PRELIMINARY STORMWATER REPORT

# The Osprey

7440 159<sup>th</sup> PI NE  
Redmond, Washington 98052

DCI Job No. 19012-0002  
June 7, 2019  
Revised: September 13, 2019  
November 13, 2019  
December 20, 2019  
March 16, 2020

# STORMWATER SYSTEM MAP

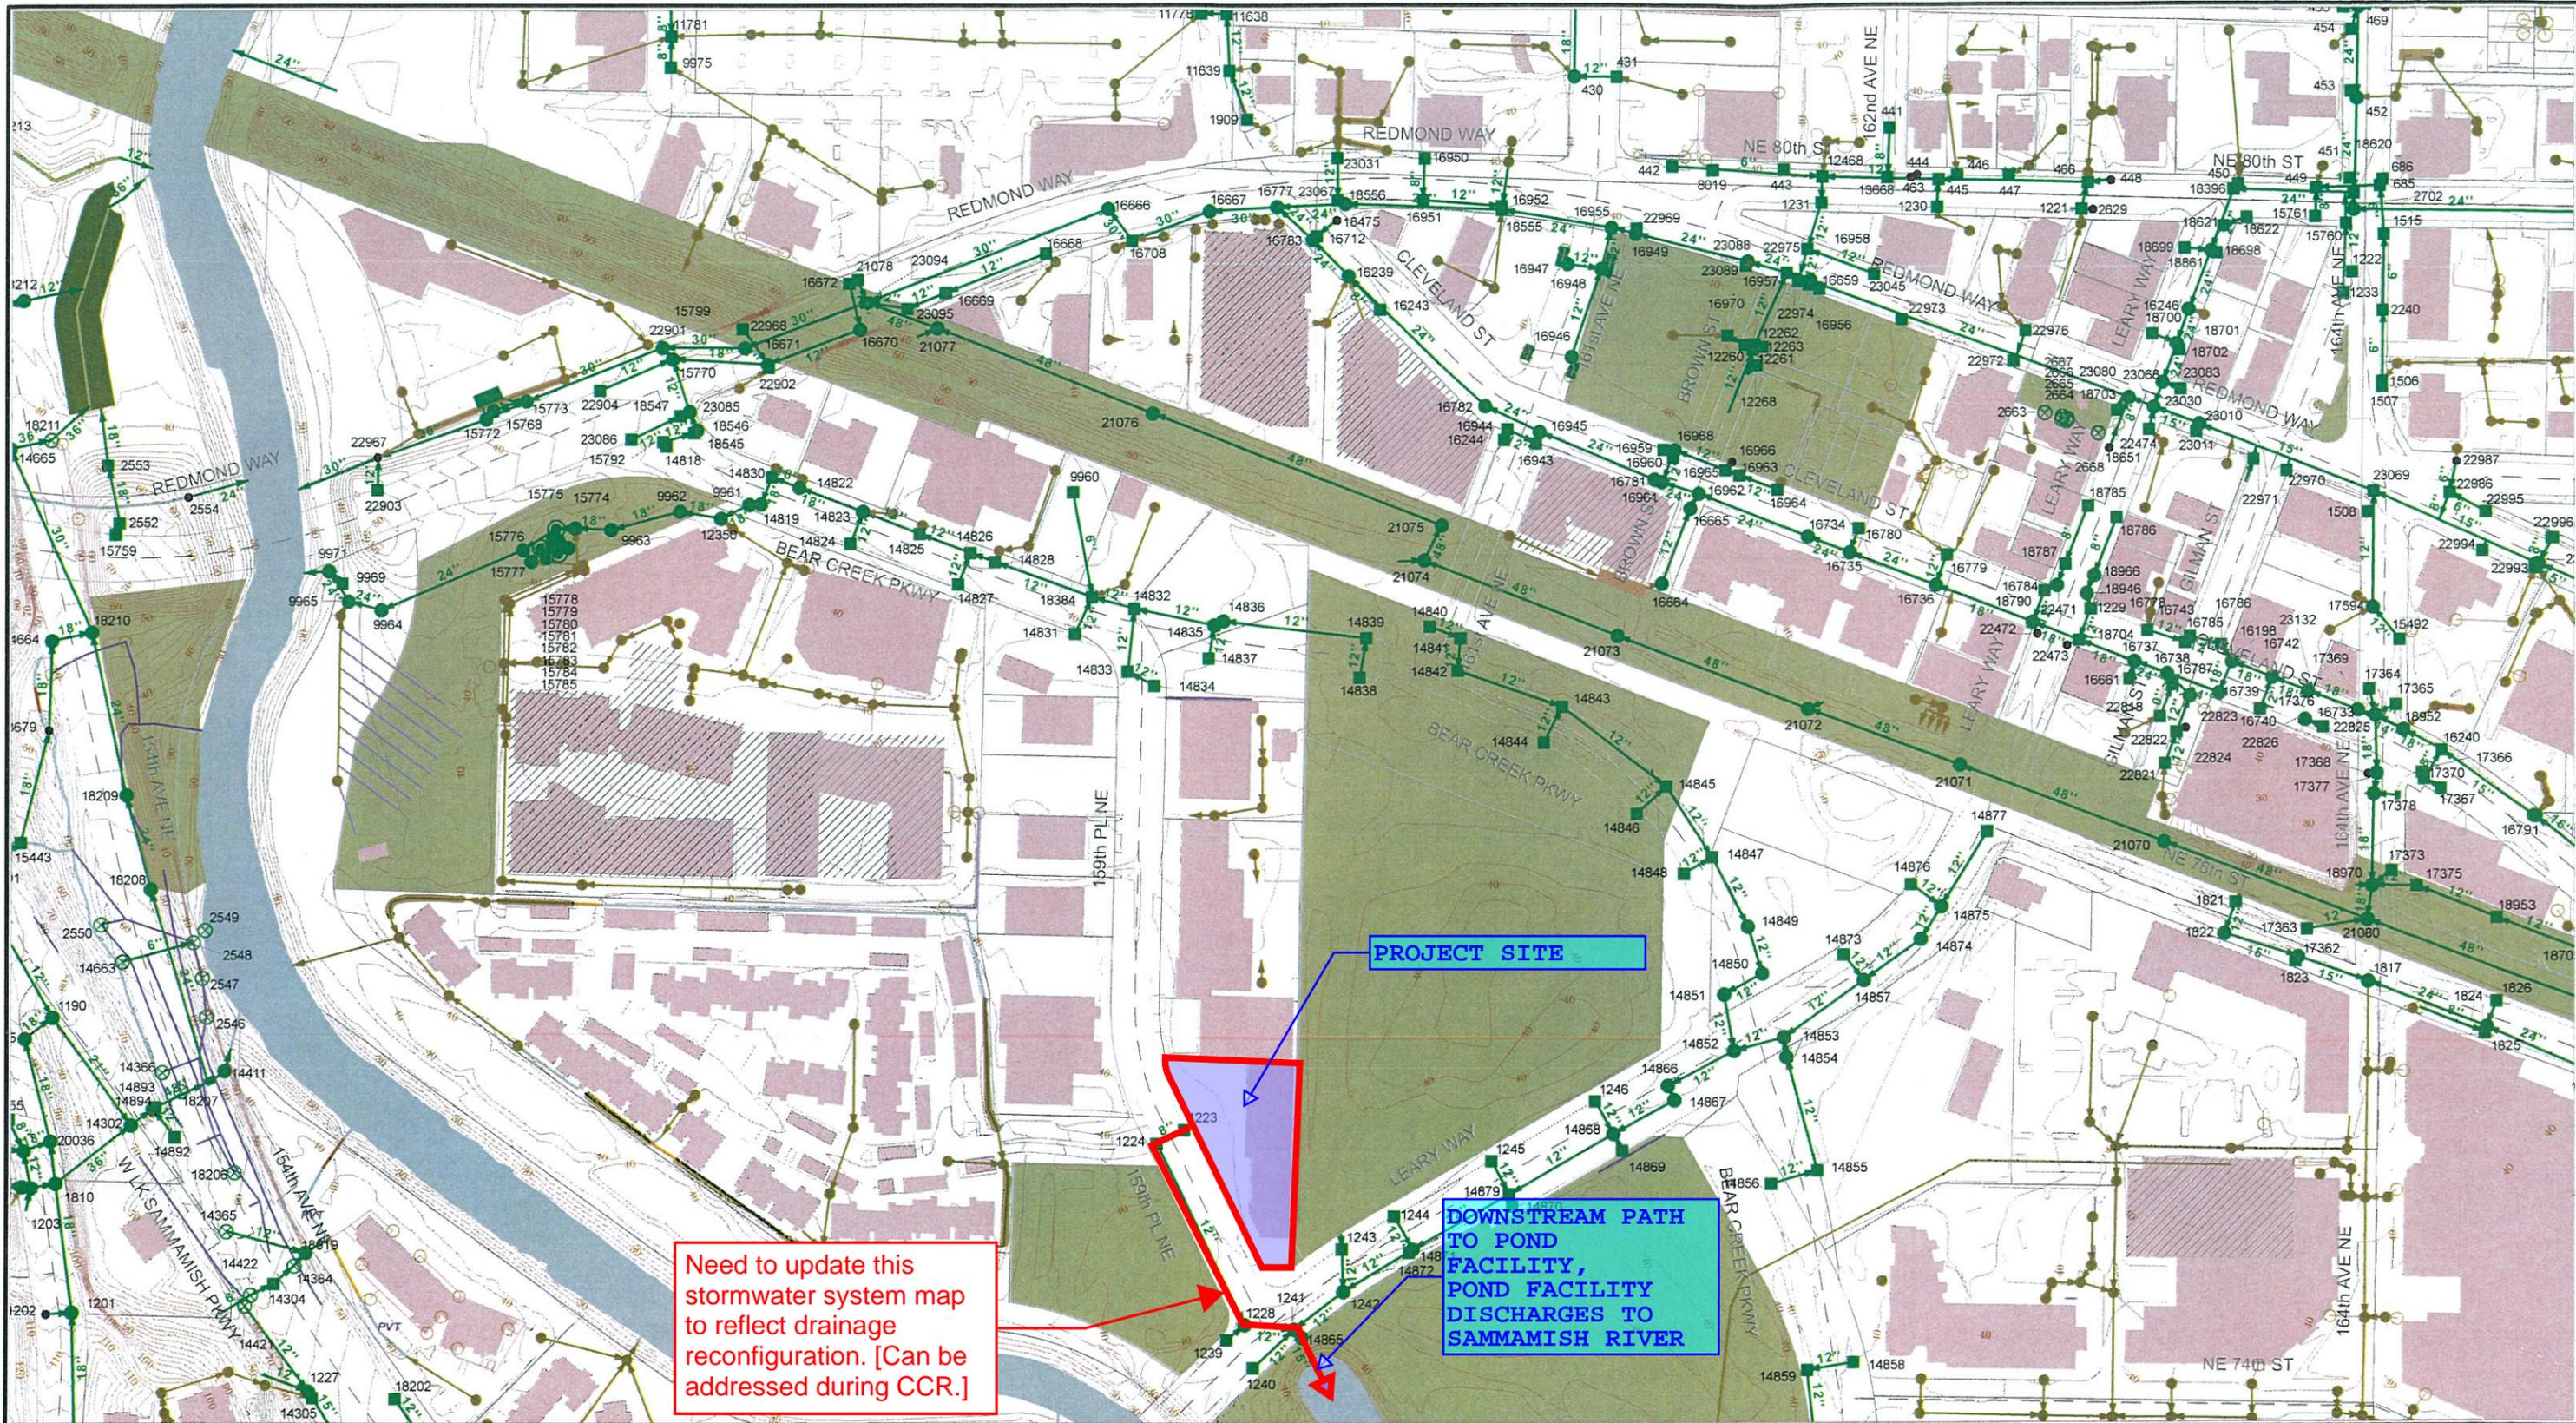
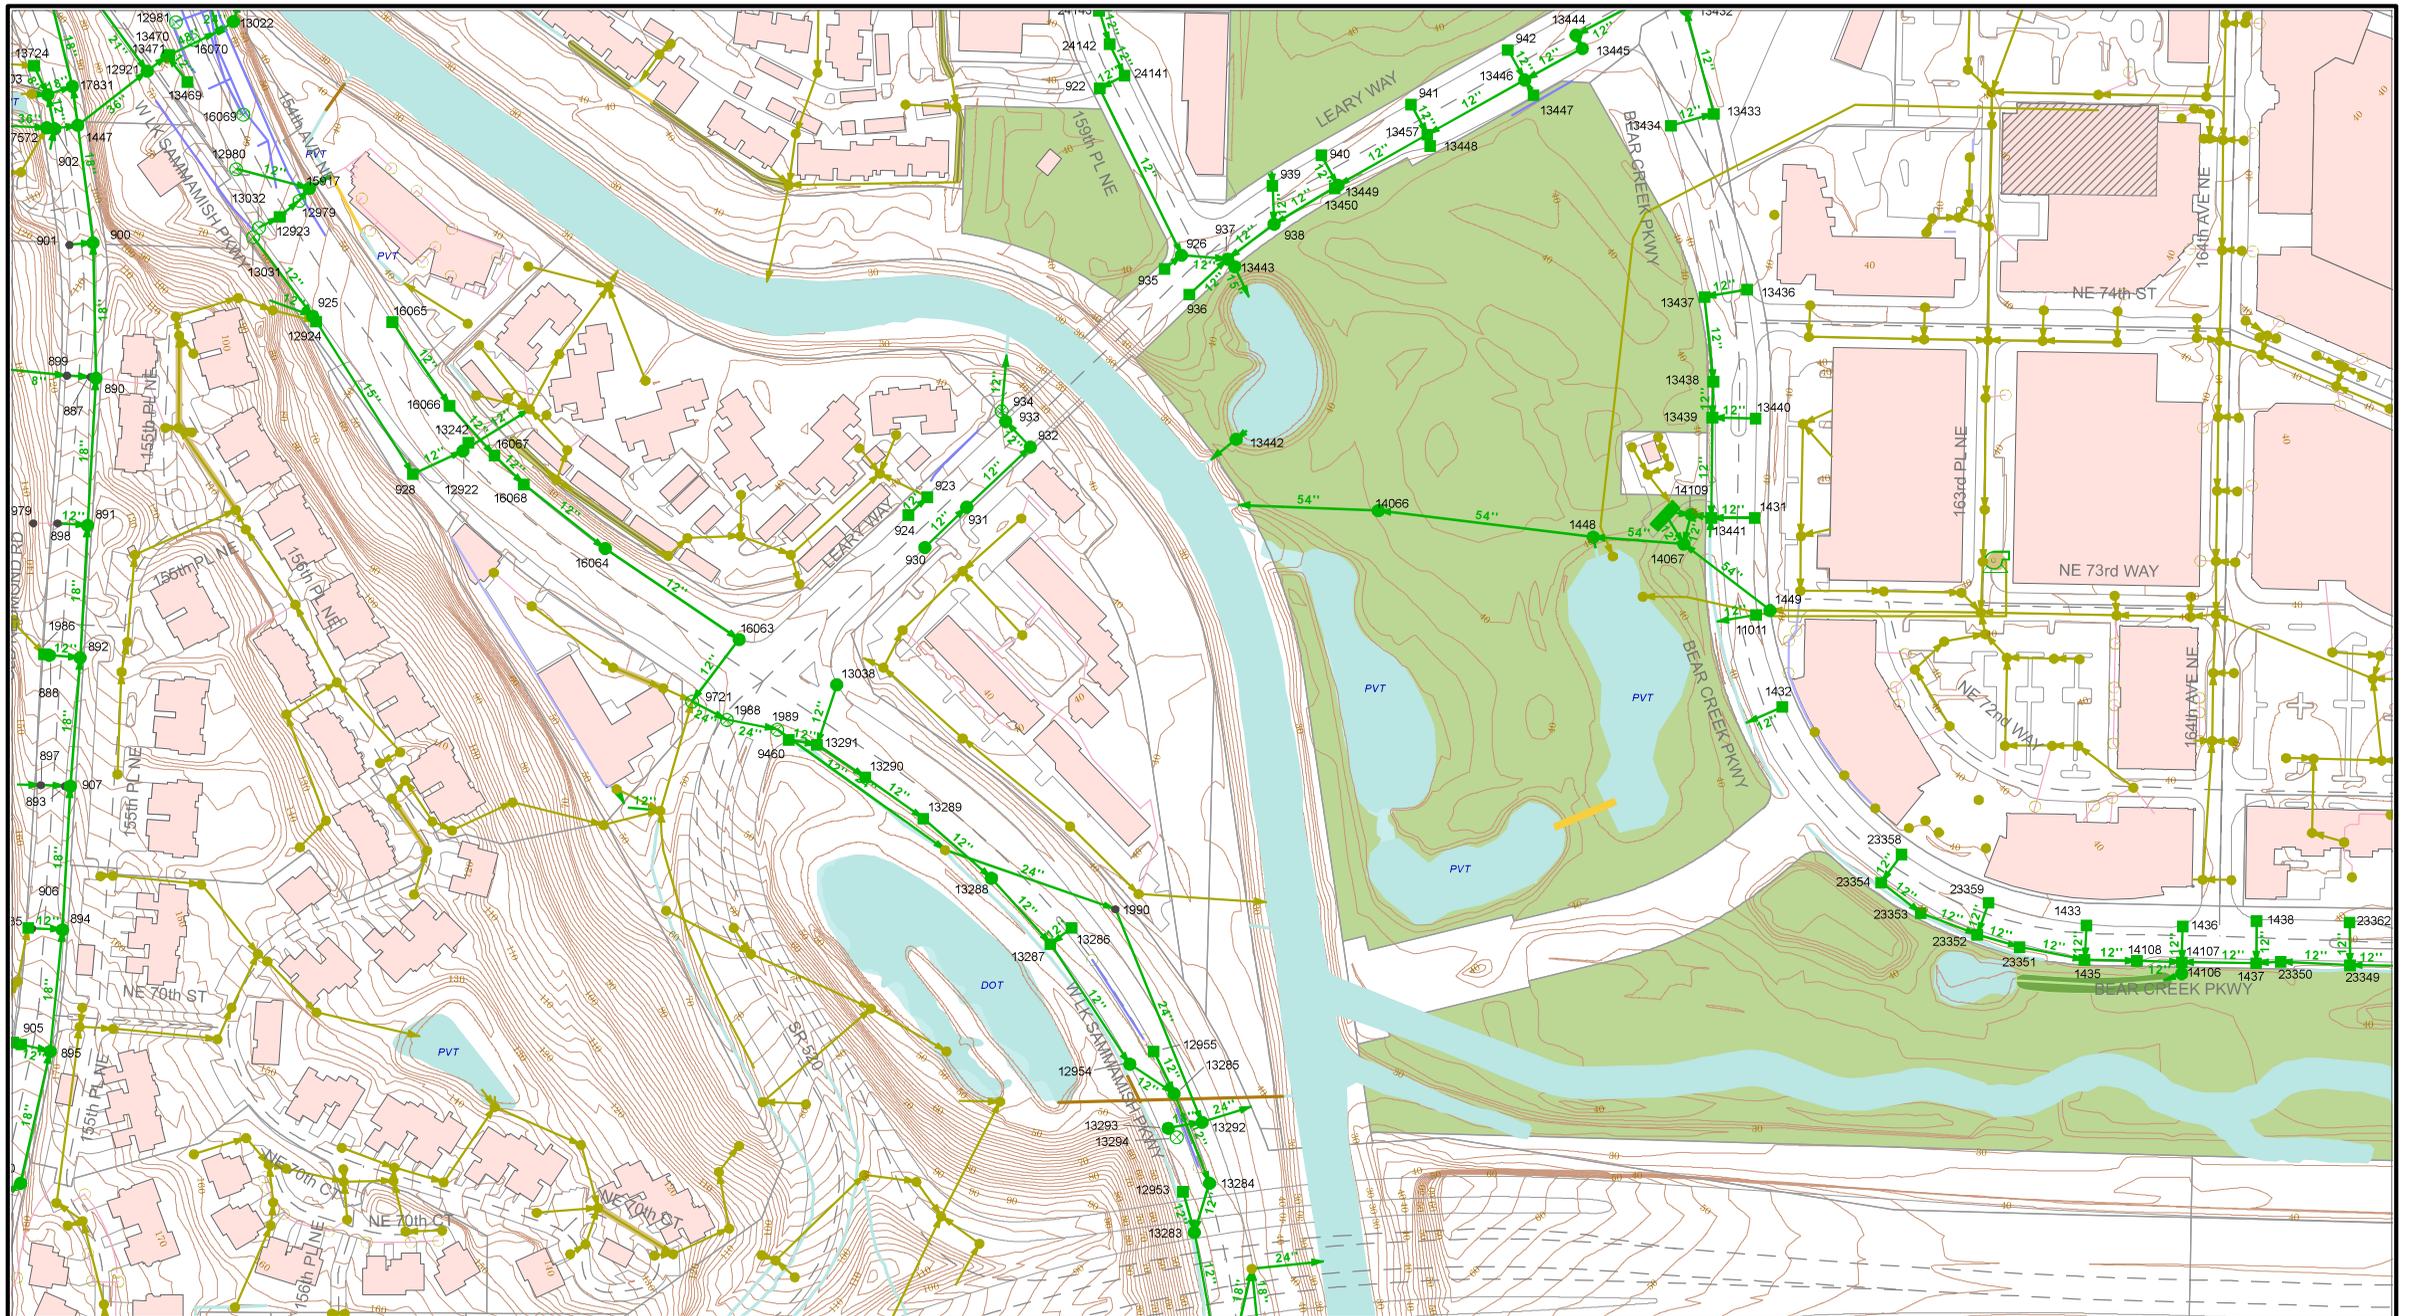
Need to update this stormwater system map to reflect drainage reconfiguration. [Can be addressed during CCR.]
